PRPTP Firmware Release Notes

VERSION 3.15r6

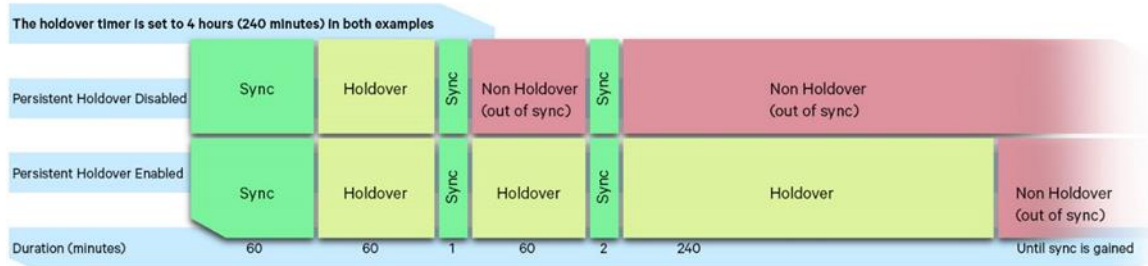
- **Feature:** Added support for enabling the persistent holdover availability option. Tekron Configuration Tool 4.2.1.10 or later is required to enable this option.

Normally, the clock can only enter holdover if it has been in sync for at least 5 minutes. If persistent holdover is enabled, and the clock has initially been in sync for at least 5 minutes, then the clock can still enter holdover if it experiences a sync switching condition. For example, sync is lost, regained for less than 5 minutes, then lost again. Such a condition may exist when GNSS jamming is present, or in the case of a poor antenna installation.

Please note, when entering holdover after a period of intermittent sync the holdover period timer is reset. This may cause the clock to enter an extended holdover period, if the sync switching condition continues to be present. By disabling persistent holdover, you can ensure that the time in holdover is not extended by periods of intermittent sync lasting less than 5 minutes.
